S E R V I C E N O T E

37717B PDH/SDH/Jitter Test Set

Mechanical Shock can Disconnect Display Cable.

Figure 1

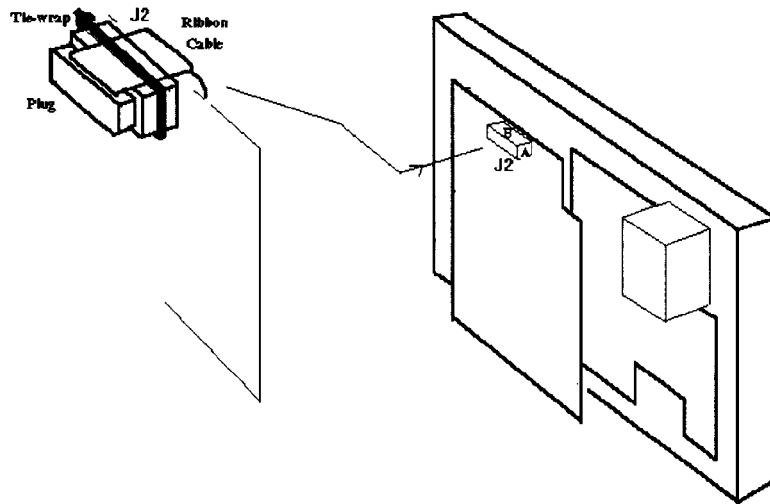
Mechanical shock can disconnect the ribbon cable interconnecting the A1 and A2 Front Panel Assemblies from A2 J2 socket. Failure symptoms will be a blank display when powered on, but with cooling fans still running.

This modification will prevent Connector A2 J2 unplugging from the socket.

6. The Front Panel can now be pulled forward out of the instrument.
7. With reference to Figure 1, remove the plug from J2 socket on the 37714-60002 (A2) assembly.

8. Cut a strip of self-adhesive tape measuring 25mm x 5mm.
9. Peel the protective backing from one side of the self-adhesive strip and attach to edges A and B of J2 socket.

10. Peel the protective backing from the other side of the self-adhesive strip.
11. Plug the ribbon cable into J2 socket and press firmly against the self-adhesive strip.

12. Fit the tie-wrap as shown in figure 1 and pull tightly.
13. Check to ensure the plug and ribbon cable cannot be pulled out of J2 socket.
14. Refit the Front Panel, outer cabinet sleeve, optical module shields and rear panel feet - this is a reversal of the removal procedure.
